**Amendments to the Drawings:**

## **Remarks**

FIG. 1

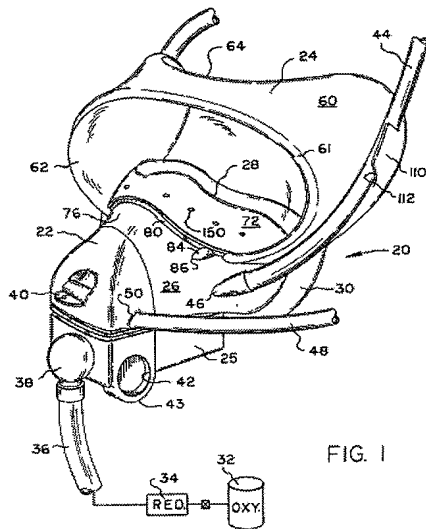
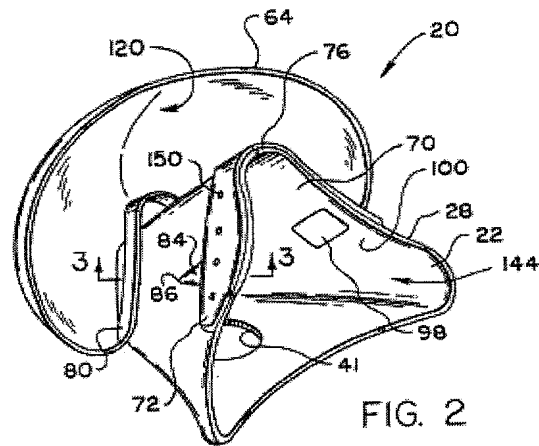
The Examiner has also objected to the figures as not showing the locking indicator of the claims. Applicants have amended the claims so that the locking indicator refers to the push button 84, as shown in figures 1 and 2. The push button performs as a locking indicator because it is integral with the pressure surface 70 of inner rod 62 of nipple 56 slidingly mounted in the shield 6 and cooperating (or not) with the first ramp 32 of the mask 2 to move from the locked position to the unlocked position.

FIG. 3

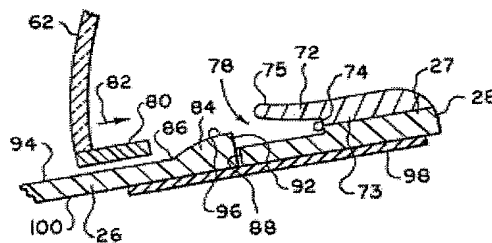
The displacement of the lock element and the screen with respect to the mask occurs once the shield is brought closer to the mask and the movement is directed **away** from the user's face, along the upper ridge of the mask shell that covers the user's nose, i.e., it is substantially along the upper bridge of the user's nose. In other words, the engagement begins closer to the user's face and moves outwardly. The incline is from the top and inside of the mask toward the bottom and outside of the mask, i.e., from the user toward the space in front of the user, i.e., **away from the mask**. The sliding component of the attaching is **outwardly sloping away from the user's face**; note the outwardly sideways slope of Figure 3 shown above.

FIG. 8

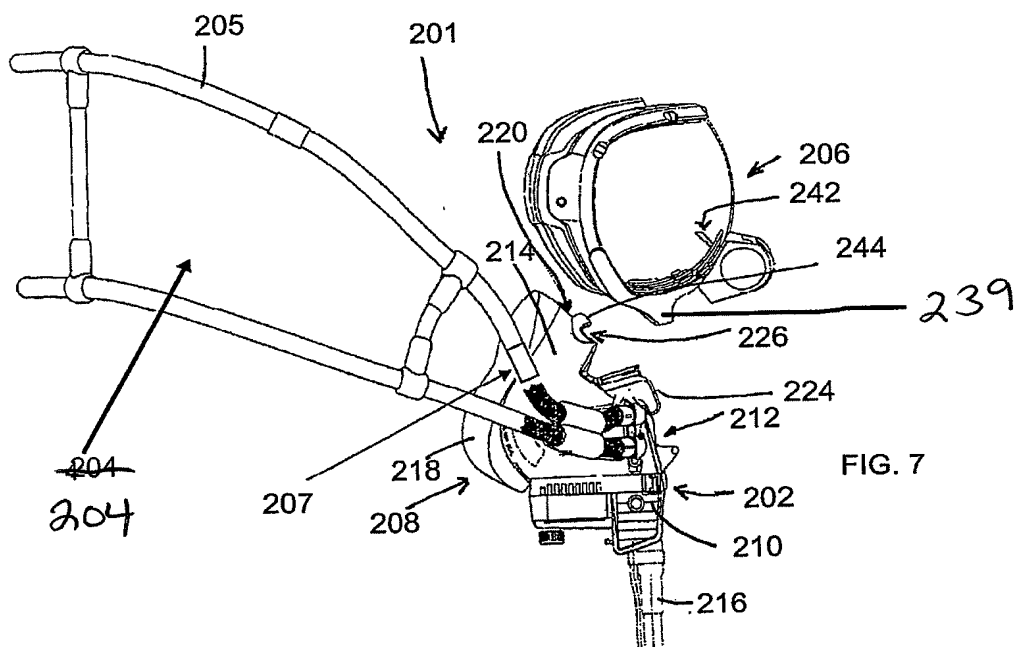
The attached sheets of replacement drawings replace all original sheets. These replacement figures are larger than those originally filed in order to better show the claimed structures, as requested by the Examiner. Reference numeral "1" has been added to Figure 1. Reference numerals 239 and 250 have been added to figures 7, 8, and 12. The shading has been removed from figures 13 and 15. No new matter has been added.
